STAFF ANALYSIS AND RECOMMENDATION YANG NON-ADMINISTRATIVE VARIANCE APPLICATION

CASE NO: P-21-089

PROPOSAL: Non-administrative variance to reduce the west rear yard setback from 30-feet to 16-feet to accommodate an accessory structure.

Figure 2: The available building envelope (building envelope = lot - setbacks) is shown in yellow

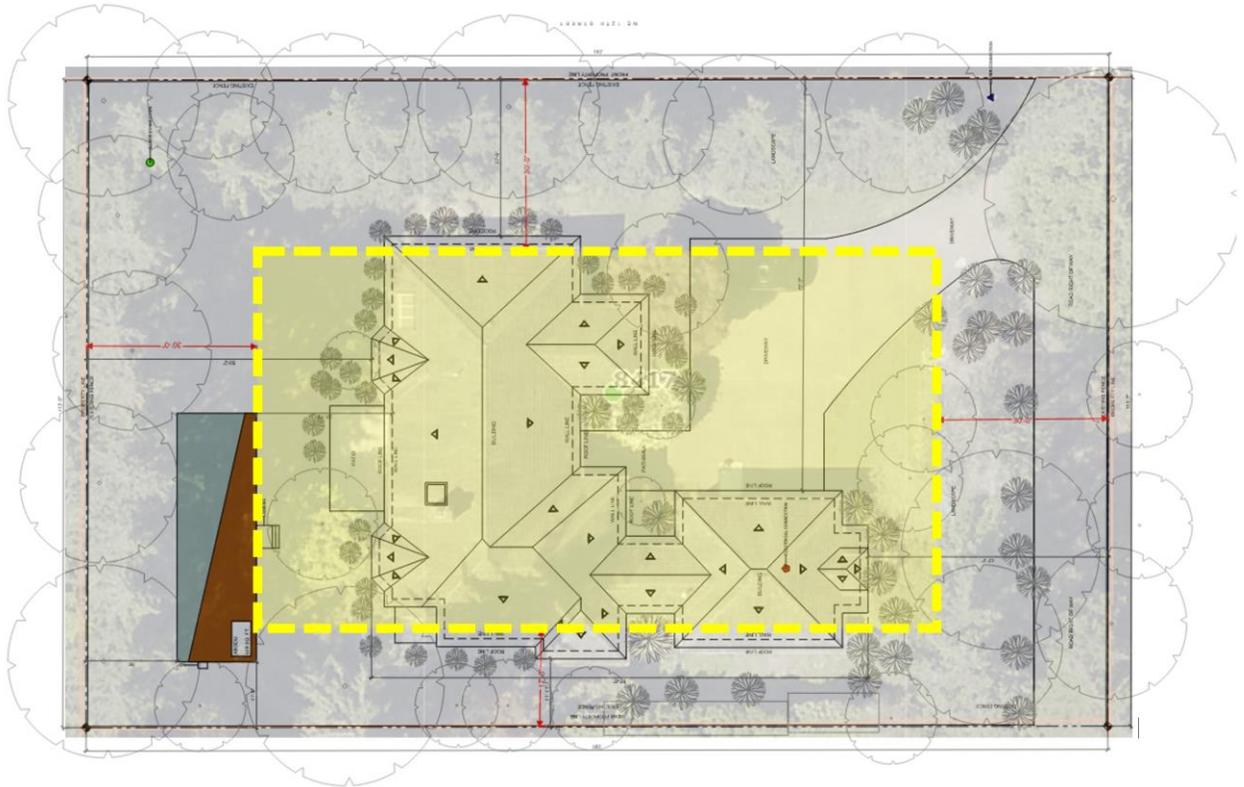
STAFF ANALYSIS: The applicant is limited to where an accessory structure can be placed on the lot (Figure 2). The placement has considered the existing mature landscape on site and has tried to limit the impact on neighbors. Whether this constitutes a material hardship related to the land itself is for the Hearing Examiner to decide.
